## 19 STATE AGENCIES

**Palmdale - Burbank - RECORD #4099 DETAIL**

# Submission 4209 (Patrica Michel, Santa Monica Mountains Conservancy, October 21, 2022)

# Submission 4512 (Ruby Kwan-Davis, California Department of Fish and Wildlife, South Coast Region 5, Habitat Conservation Planning Program, December 1, 2022)

Figure 1 –Aerial photograph showing wildlife movement opportunities, looking north from Agua Dulce Canyon Road, through the Linkage Design, across the SR 14 freeway corridor with UC Davis Wildlife-Vehicle Conflict Hotspots identified.

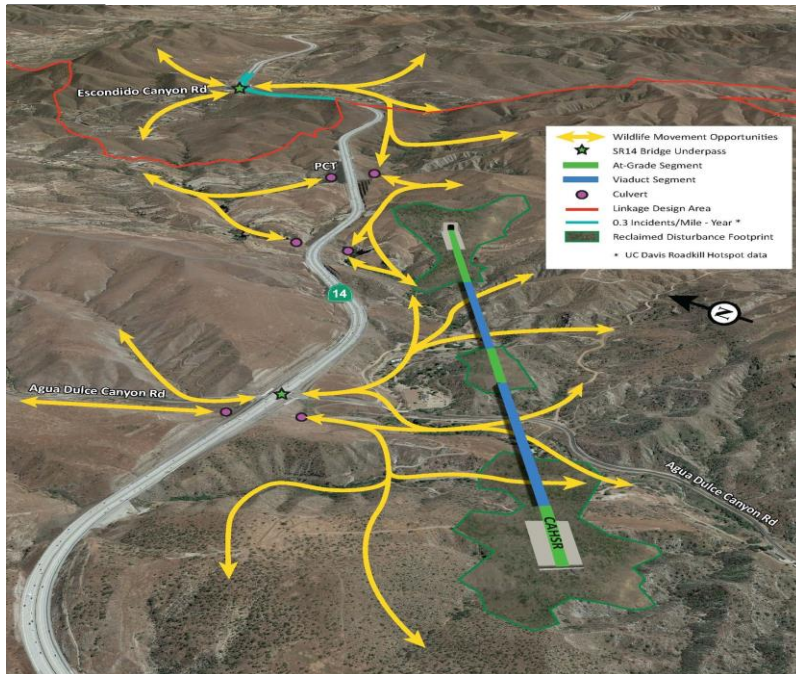
The viaducts and tunnels associated with the SR14A and Refined SR14 Build Alternatives provide for unimpeded movement across the alignment and align with the existing bridge crossing opportunities underneath the SR 14 freeway. The extensive series of tunnels and viaducts that maintain wildlife movement opportunities are listed in Table 6-6 in the WCA and Table 2-13 of the WCA Supplement. Figure 5-4 in the WCA identifies the existing bridges on the SR 14 freeway that provide wildlife crossing opportunities that align with tunnel and viaduct segments to facilitate wildlife movement in a manner that closely approximates existing conditions.

Furthermore, Figure 4-5 in the WCA shows the spatial relationship between these wildlife crossing opportunities at the existing bridges on the SR 14 freeway and the tunnel and viaduct segments of the alignment and how the existing wildlife movement opportunities are maintained as a result. Figures 1 and 2 below further illustrate how existing wildlife movement opportunities across the SR 14 freeway line up with the adjacent permeable tunnel and viaduct segments for the SR14A Build Alternative to maintain wildlife movement and gene flow.

existing crossing opportunities, which are corroborated by the recent UC Davis data on high wildlife use hotspot areas. As described above and shown in Figures 1 and 2, the Refined SR14 Build Alternatives and SR14A Build Alternatives contain a large network of tunnels and viaducts that align with the existing crossing opportunities [existing bridges and high wildlife use hotspot areas (UC Davis 2023)] to maintain existing wildlife movement opportunities and gene flow. As such, a mountain lion crossing monitoring plan is not required.
